Access Compliance Report

Public Rights-of-Way

(Curb Ramps)

Intersection ID: 10027788	Main Street: GUNPOWDER_POINT_DR	Cross Street: N/A	Location: S
ADA ID: 5C53004FC78B	Ramp Type: Perp	Initial Pass/Fail: Fail	Overall Compliance: No
Severity Score: 12.5			
Codes/Mitigation Info/Possible Solution		Field Measurements/Component Compliance

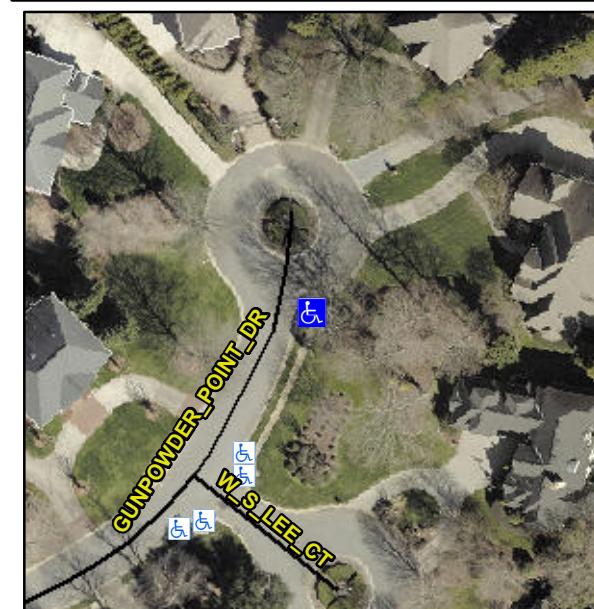
Not Found, R304.2.2

Compliance	Description	Data	Compliance	Description	Data
N/A	Ramp Length (in)	40.0	No	Ramp Slope (%)	11.9
Yes	Ramp Width (in)	52.0	Yes	Ramp XSlope (%)	0.1
N/A	Flare Type LT	N/A	N/A	Flare Type RT	N/A
N/A	Flare Slope LT (%)	N/A	N/A	Flare Slope RT (%)	N/A
N/A	Flare Traversable LT?	N/A	N/A	Flare Traversable RT?	N/A
N/A	Landing Length (in)	N/A	N/A	DWS Provided?	N/A
N/A	Landing Width (in)	N/A	N/A	DWS Contrast?	N/A
N/A	Landing Slope (%)	N/A	N/A	DWS Length (in)	N/A
N/A	Landing X Slope (%)	N/A	N/A	DWS Full Width?	N/A
N/A	Landing Curb? (Y/N)	N/A	N/A	DWS Offset (in)	N/A
N/A	Shared Landing?	N/A			
N/A	Gutter Ponding?	N/A	N/A	Gutter Slope (%)	N/A
N/A	Gutter Lip Ht (in)	N/A	N/A	Gutter X Slope (%)	N/A
N/A	Painted X Walk1?	No	N/A	Painted X Walk2?	N/A
	X Walk 1 Direction	To NW		X Walk 2 Direction	N/A
N/A	X Walk 1 Width (in)	N/A	N/A	X Walk 2 Width (in)	N/A
	X Walk 1 Slope (%)	3.4		X Walk 2 Slope (%)	N/A
	X Walk 1 X Slope (%)	0.6		X Walk 2 X Slope (%)	N/A

Remove & Replace Entire Ramp.
